PROJECT BRIEF

Historic District Board of Review Application for Certificate of Appropriateness at 407 E. Vaughn Dr. to build top floor addition on north side of structure.

HDBR Meeting Date: September 25, 2023

② Level 2 Proposed Floor Plan
1/4" = 1'-0"

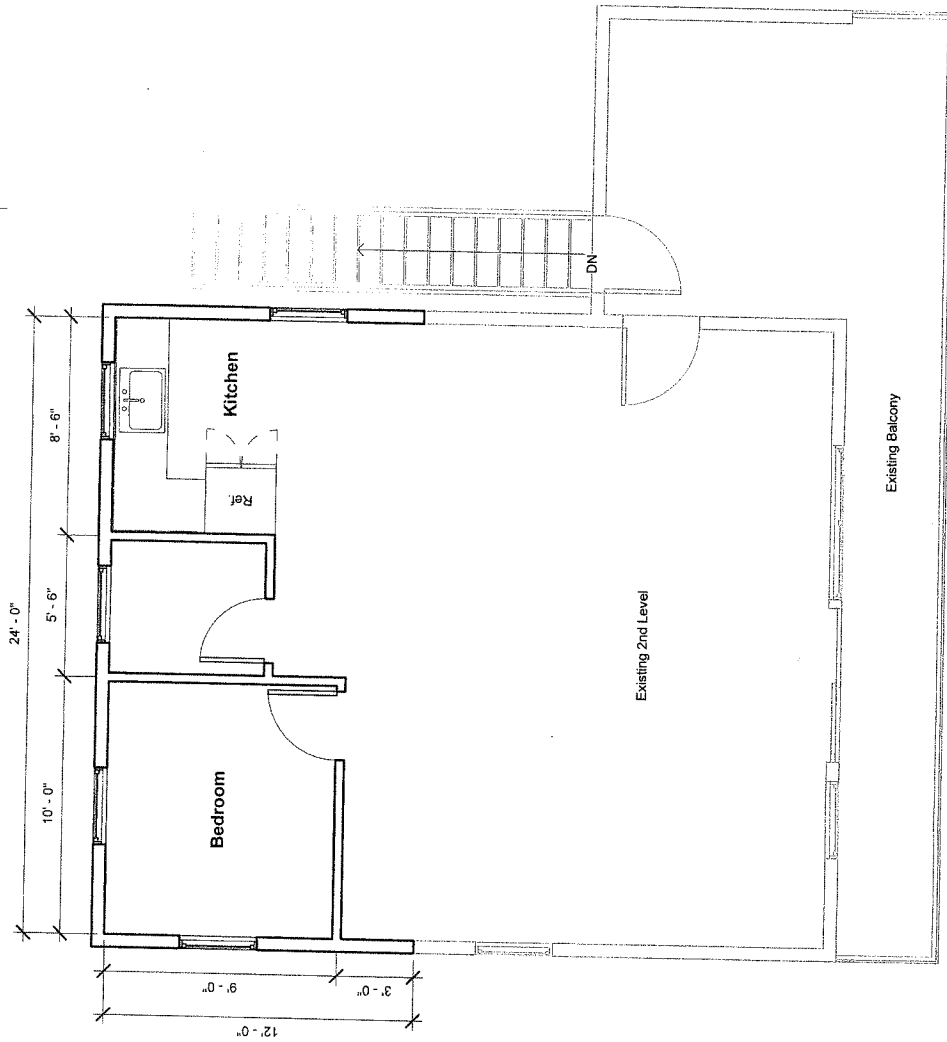
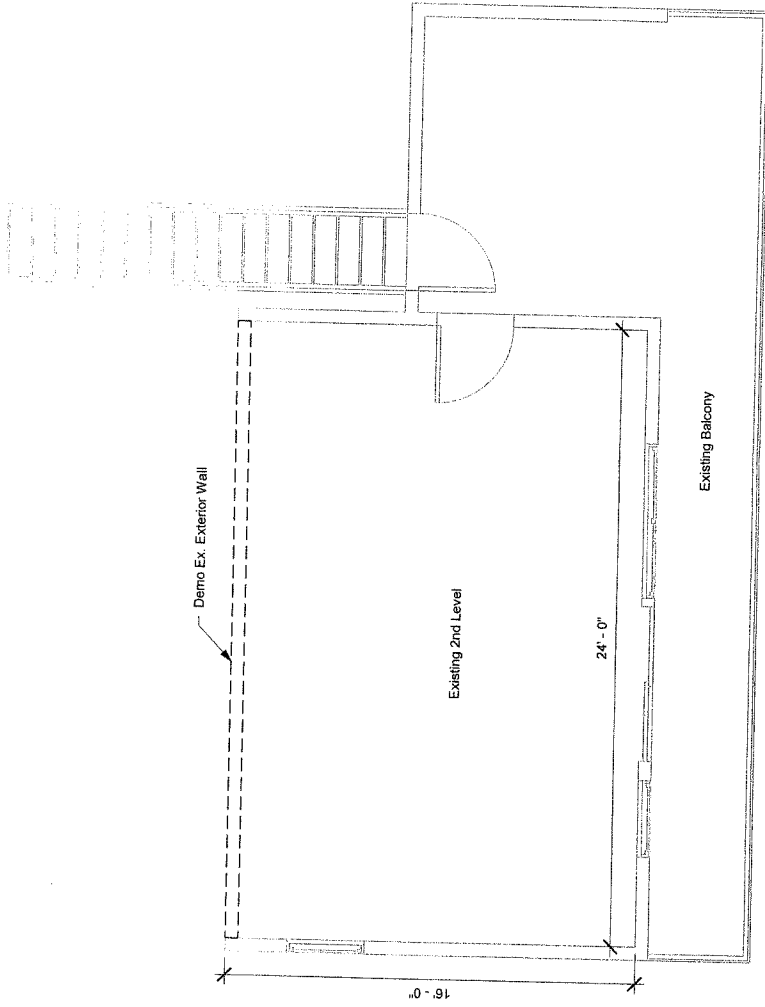
The project *is in* conformance with Guideline 26.1 because the proposed new addition will be placed on the north but is *not in* conformance because the addition will affect a primary façade [this structure is located on a highly visible corner, so all sides are highly visible; however, given its status as a non-contributing structure, the addition will not have any impact upon the designation rating]; *is in*

conformance with Guideline 26.2-26.3 because the proposed addition is of the appropriate massing in relation to the existing structure and the new materials will match existing materials; is *not* in conformance with Guideline 26.4 because the new addition will require the demolition of the entire north wall [unknown if the north wall is a historic original wall or contemporary wall]; *is in* conformance with 26.6-26.9 because the new windows will match the existing windows, the foundation will be the same or compatible to the existing, and prior alterations/additions have been considered and factored in to the design of the proposed new addition; *is in* conformance with the Ordinance because the proposed materials and addition will be visually compatible with the existing structure; and is *not* in conformance with SOI for Rehabilitation because the proposed alterations involve more than minimal exterior visual change.
